STERLING RANCH FILING NO.2

STORM SEWER PLANS

APRIL 2021

SF-20-015

STRM_23 PROFILE STA 26+00.00 TO 40+00.00 PRIVATE (STRMD)

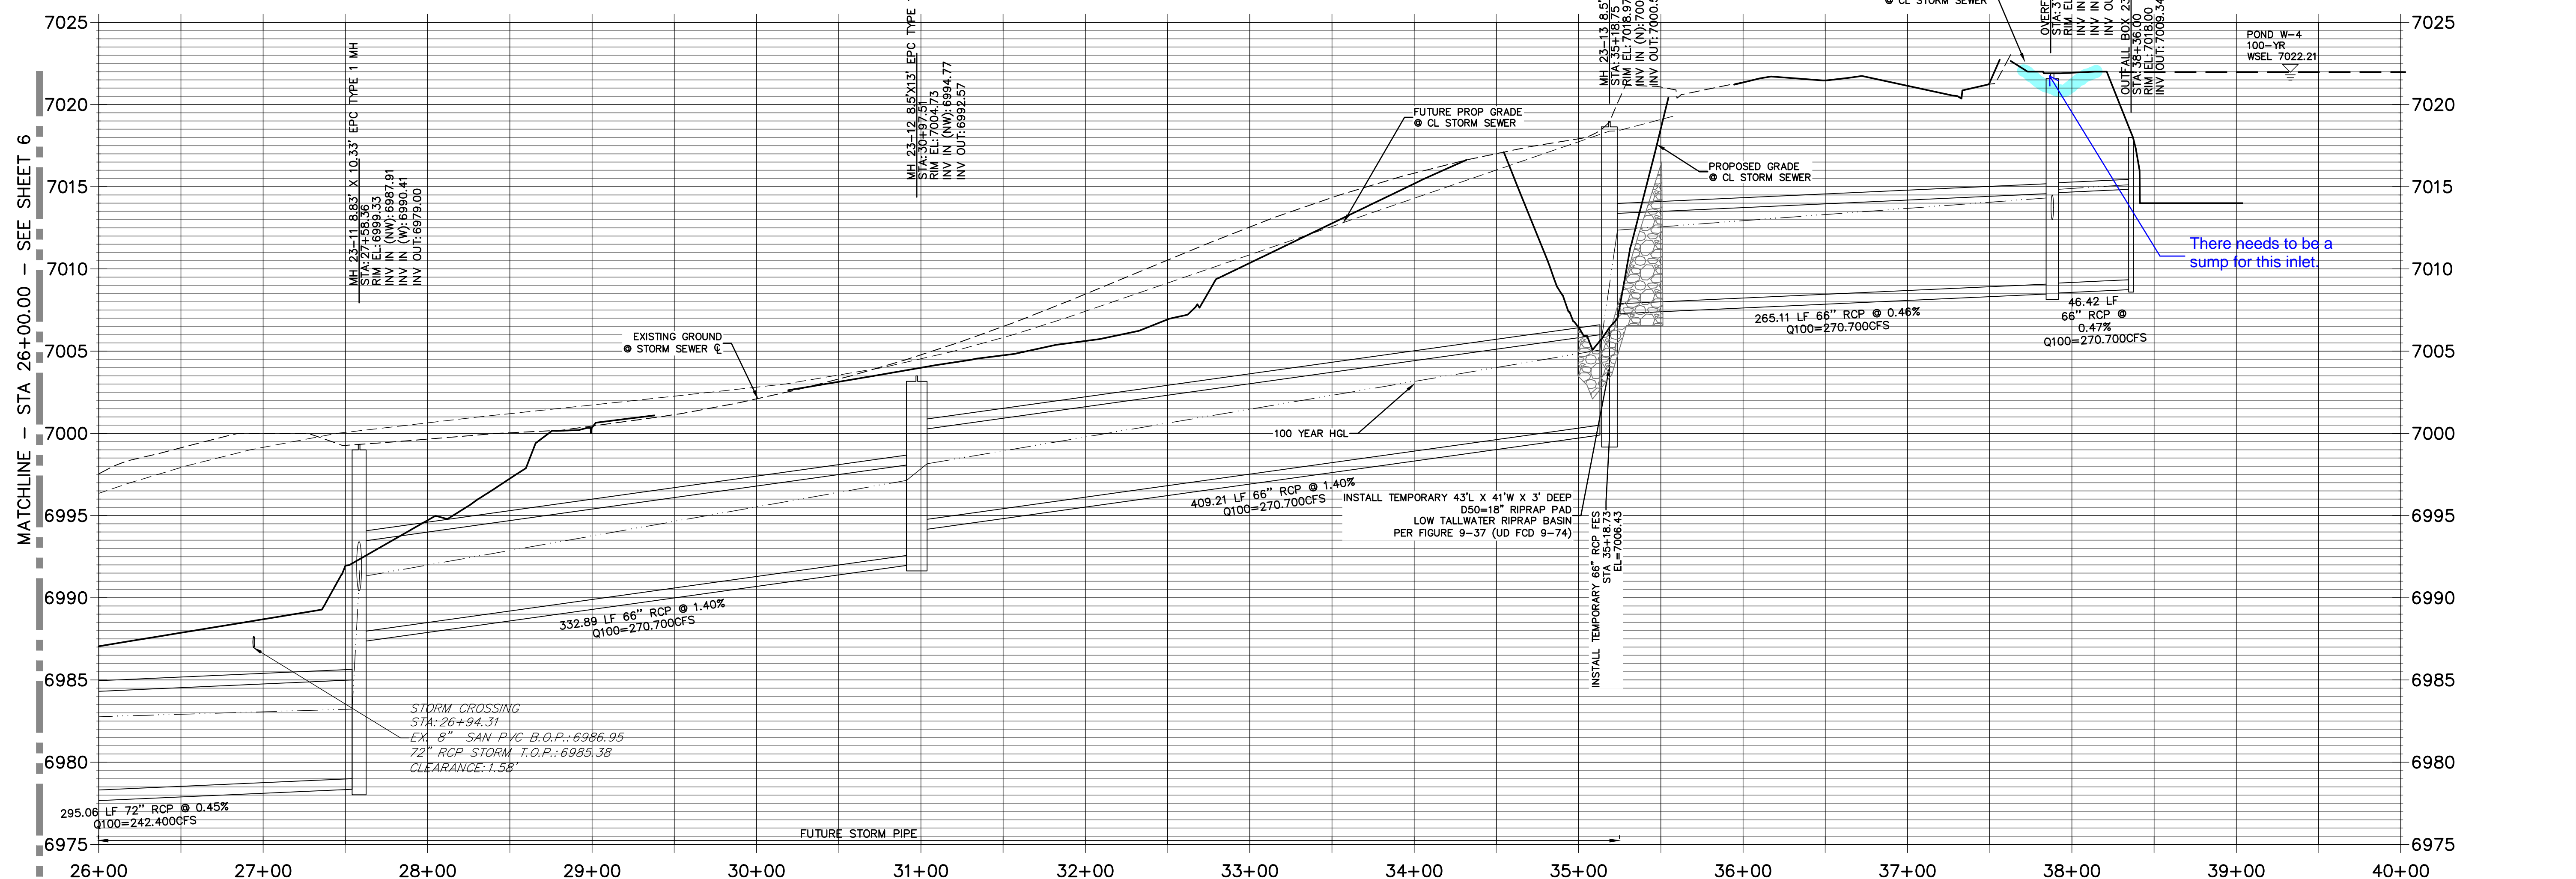
There needs to be a sump for this inlet.

POND W-5 WATER QUALITY OUTLET STRUCTURE
NOT TO SCALE

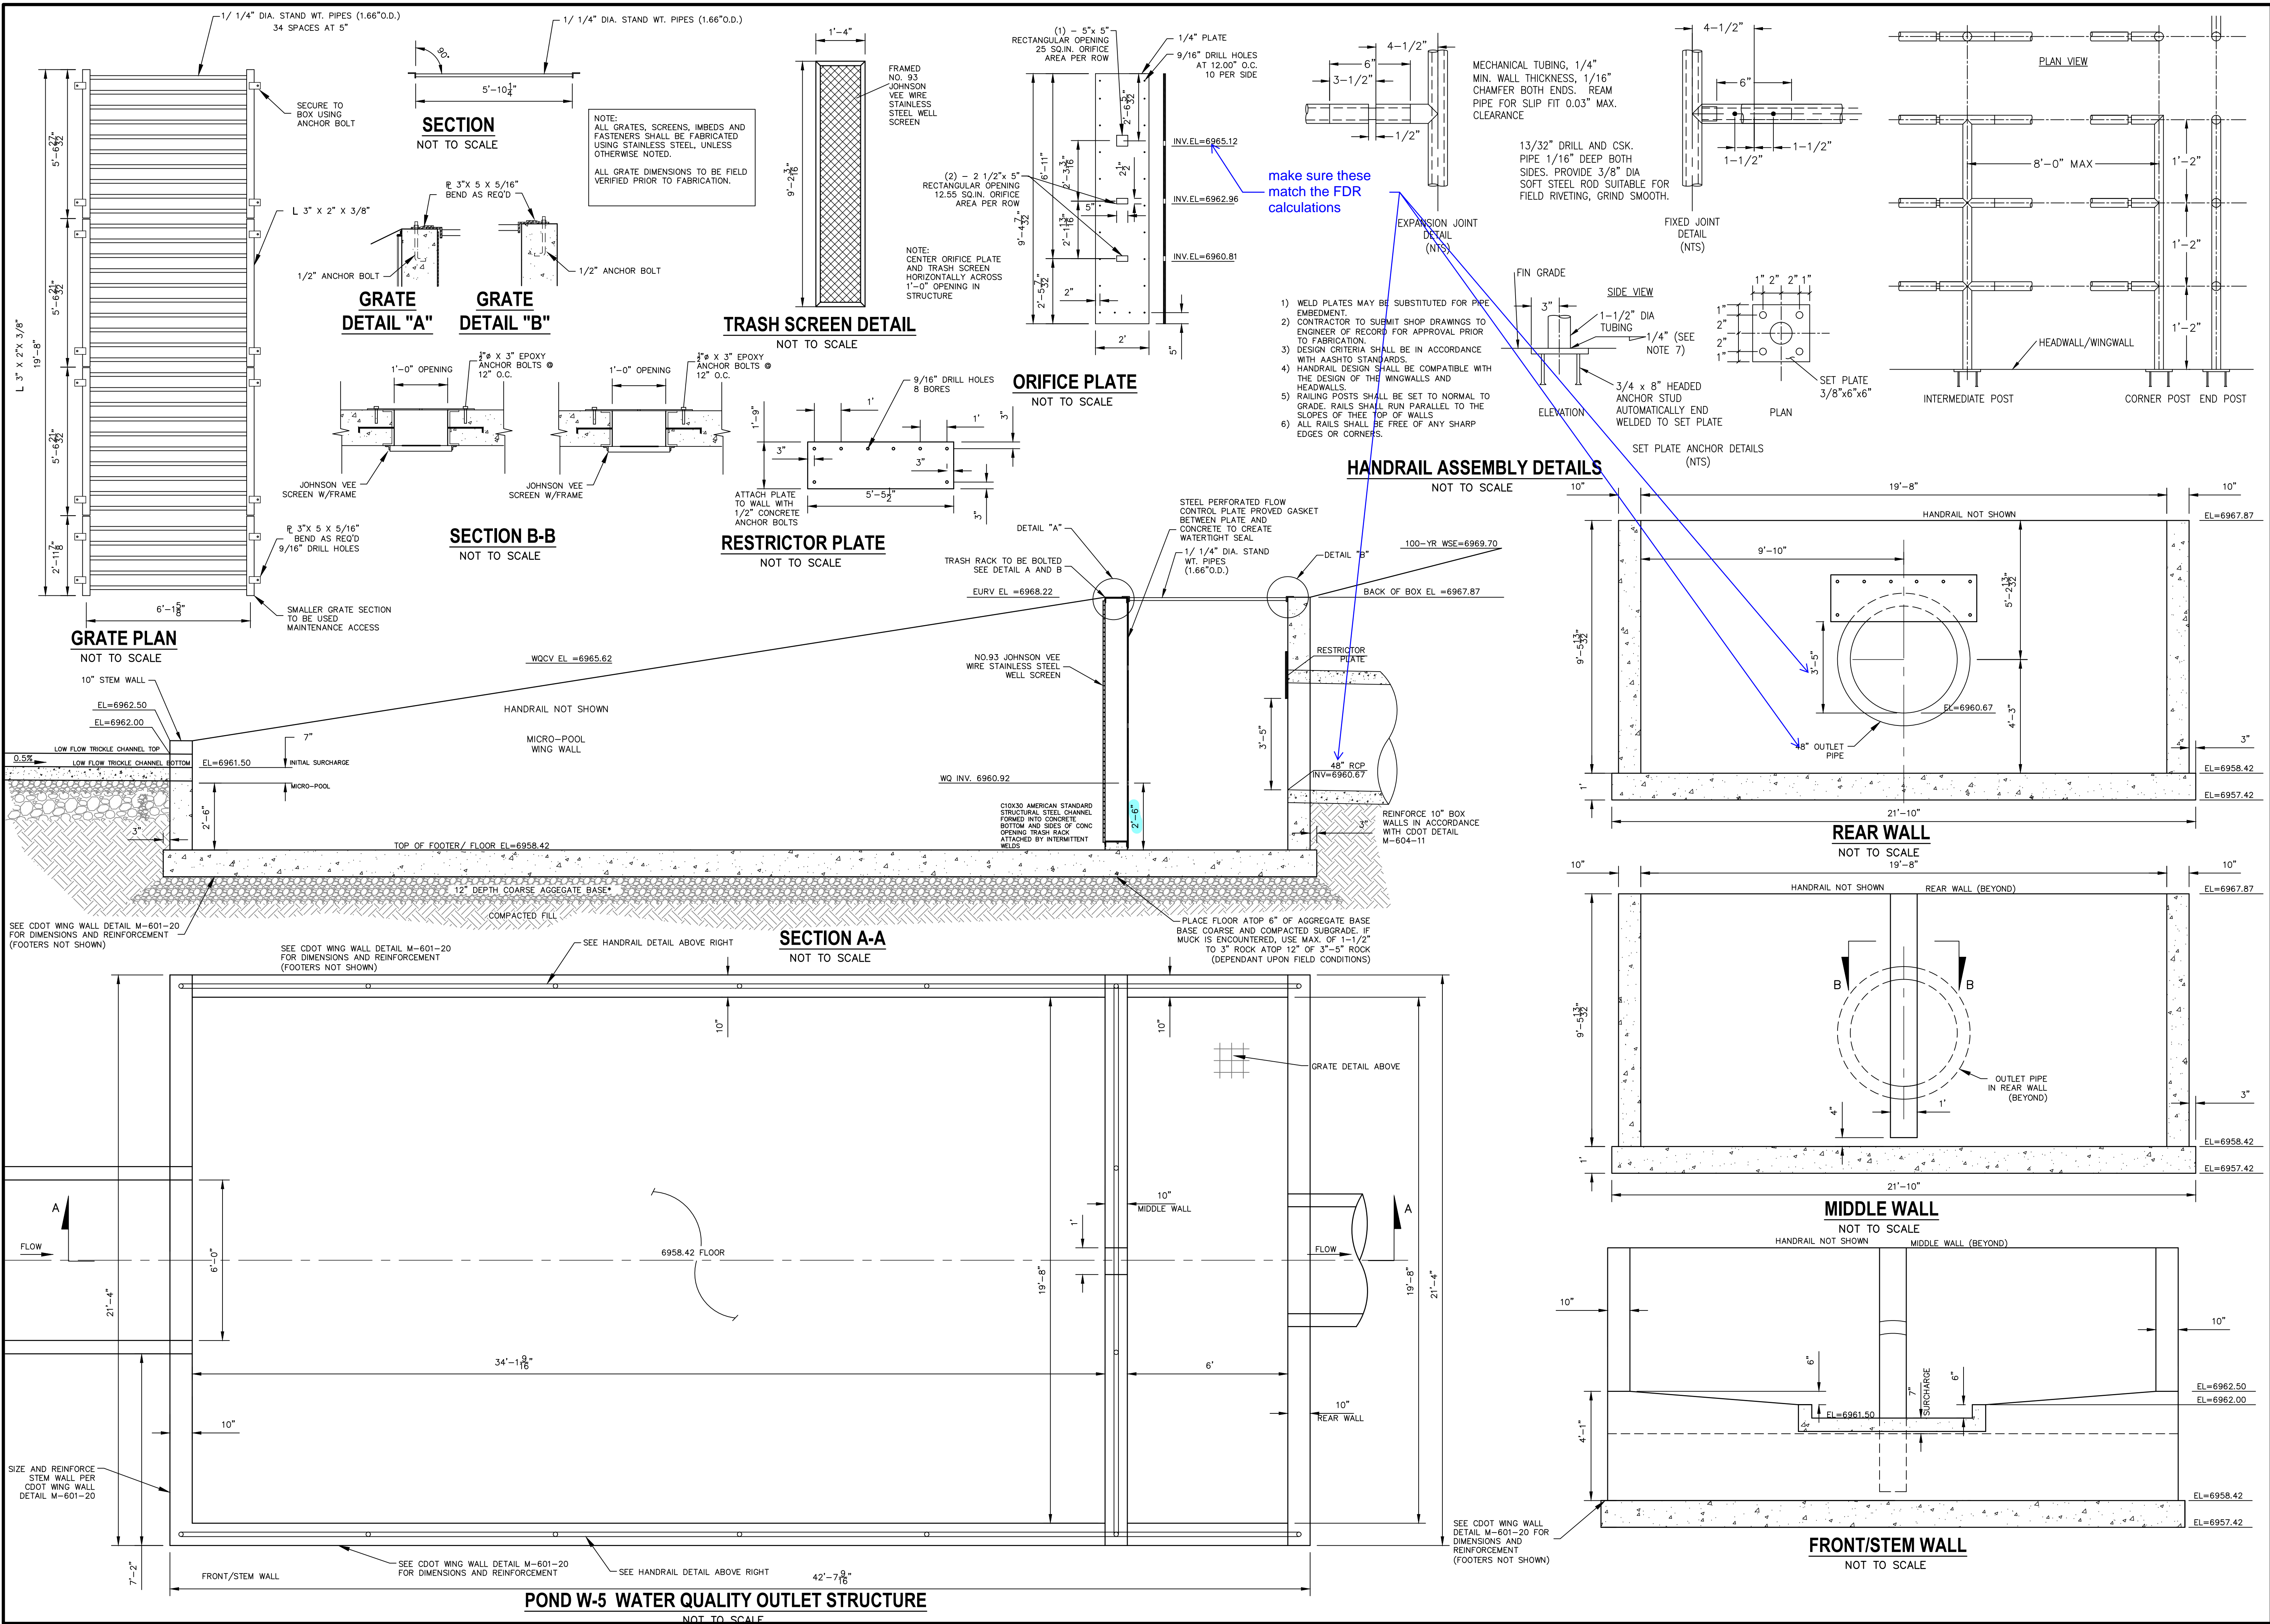
make sure these match the FDR calculations

FULL SPECTRUM DETENTION POND W-4
SITE PLAN
SCALE 1"=30'

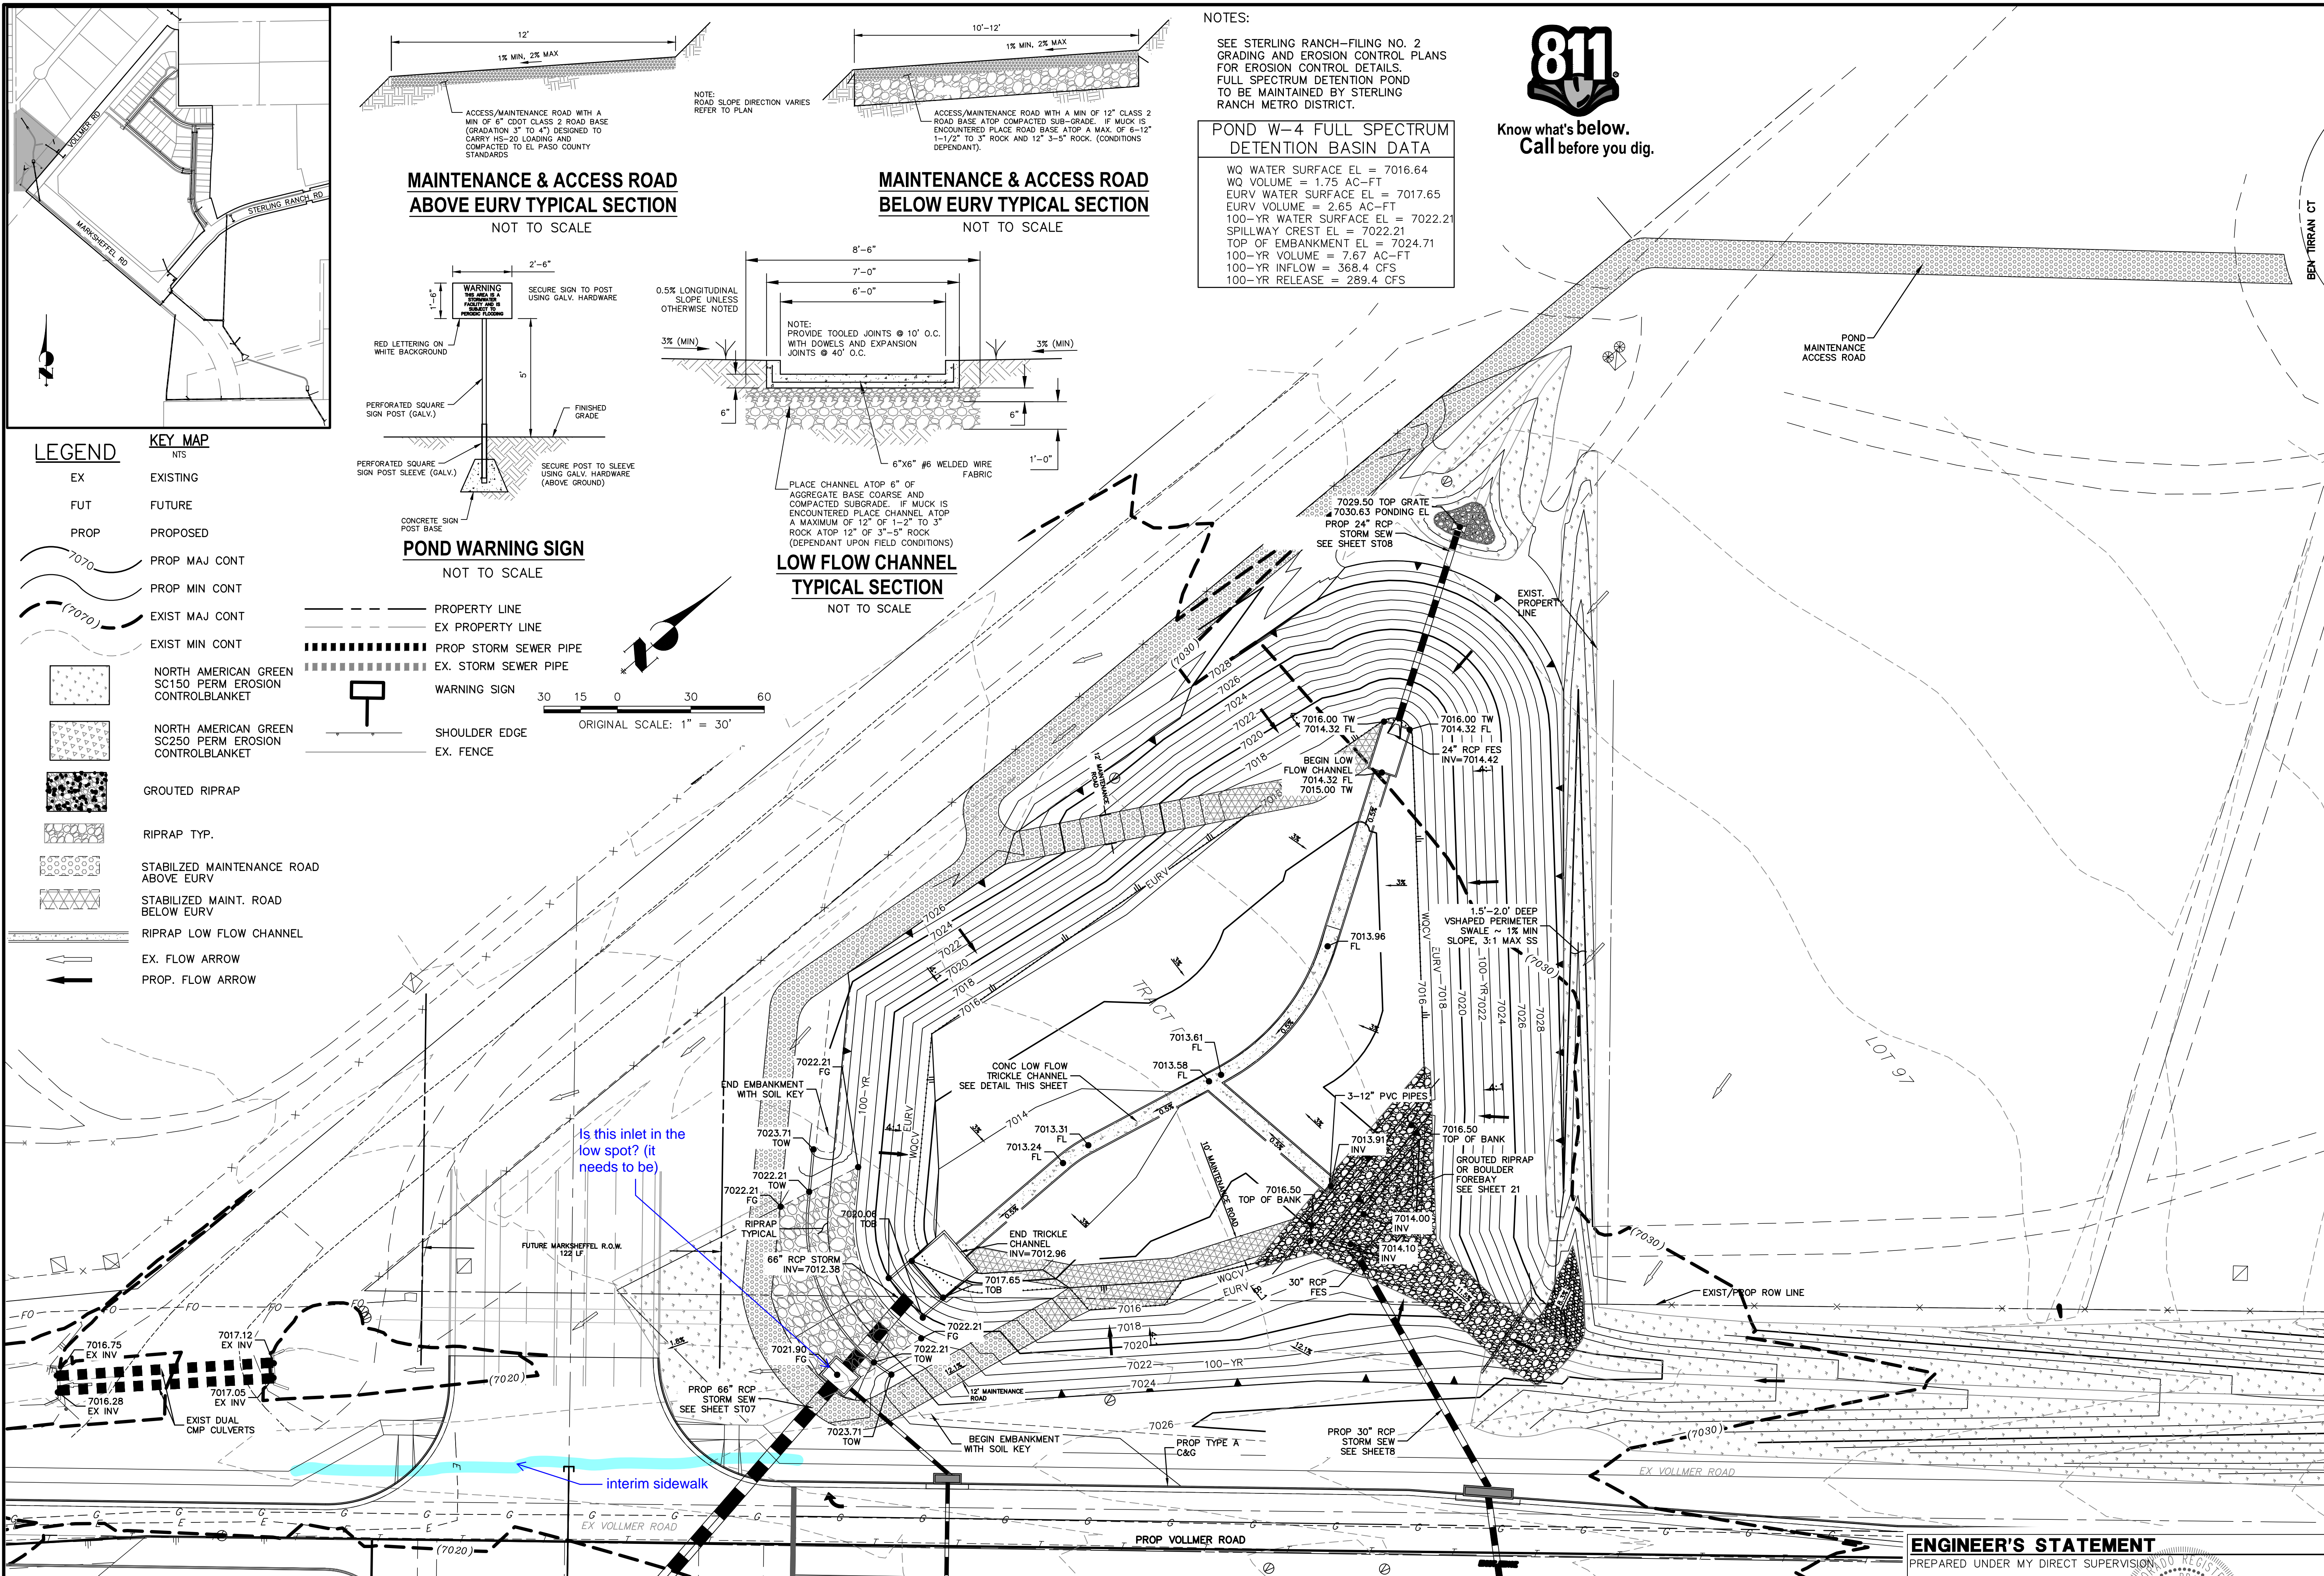
Is this inlet in the low spot? (it needs to be)
